Ref: 24124

Manor Farm, Collingbourne Kingston, Wilts, SN8 3SD
Nutrient Assessment and Statement

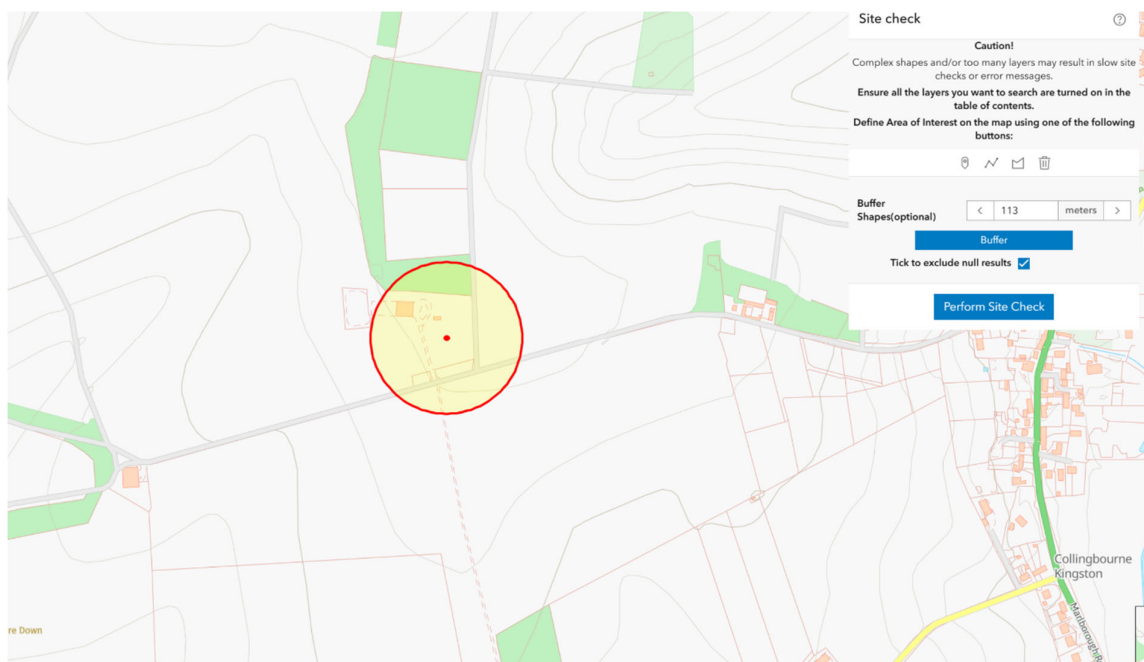
- 1 The PTP and drainage field are not shown on site plans. This information should be shown on plans.
- 2 Conditions (c), (d) and (f) of Natural England methodology 16 March 2022- Annex F. Further information/clarification required.
- 3 Annex F Condition (g). There is an existing slurry pit to the northeast of site that may be contributing to nutrient discharge. The submission has not addressed the potential for this to be an in-combination effect. Details on the existing slurry pit should be provided as an in-combination effect must be ruled out. This may include plans and specs of slurry pit containment.

- 1) You have updated your site plan to address this.
- 2) (c) I note from google earth interrogation tools that the ground level variation appears to be no more than 1m over a site parcel width of about 50m ie slope cannot be more than 2% so well below 15 degrees.

(d) The site is located on a hilltop in a region of very thick permeable chalk geology at some 184mAOD, some 50m above the valley floor at 134mAOD. We conclude from this that groundwater level at the site is significantly >2mbgl. BGS borehole record SU25NW14 for Mill Drove Parsonage Farm at some 168m AOD determined a ground water level of some 43mbgl so considerably more than 2mbgl, and Manor Farm is located at the top of the same hill at 16m greater elevation so would have a greater height above groundwater level, also much greater than 2mbgl.

(f) I do not know there to be any other factors.

- 3) (g) Only residential sewage forms part of the assessment. Whilst animal waste may be placed in a slurry pit rather than be present in the same amount in other distribution is incidental as the land use on the farm is existing and the development proposal does not change the land use type elsewhere on the farm (including slurry pit) and does not change the land use so would not change the nutrient. Footnote 22 to (g) states this is looking at the relationship between 2 drainage fields to 2 septic tanks..... (1) the slurry pit is NOT a septic tank; (2) the slurry pit is NOT a drainage field and (3) the nutrient methodology relates only to residential occupancy sewage and the slurry pit is not residential occupancy sewage. footnote 22 continues that the aim is that 'these systems' meaning drainage fields to septic tanks is to seek to get only 1 residential discharge per 4 ha (40,000m²) ie radius of 113m to each 4 Ha cell. the next nearest residential property (and its discharge is well beyond 113m

You should also note that a slurry pit is generally an open holding tank and the farmer then later muck spreads the slurry back onto his fields in accordance with DEFRA farming practices. So the nutrients in the slurry arising from the land use farming activity are distributed onto the land and in effect give the same distribution of the same animal waste as were the cattle permanently free ranging the site and give the land use nutrient values.

Furthermore a default septic tank 11.6 mg/L TP could be installed under the same Annex F below threshold but the applicant proposes a PTP at 1.6 mg/L which lowers TP by 87% of a septic tank baseline value
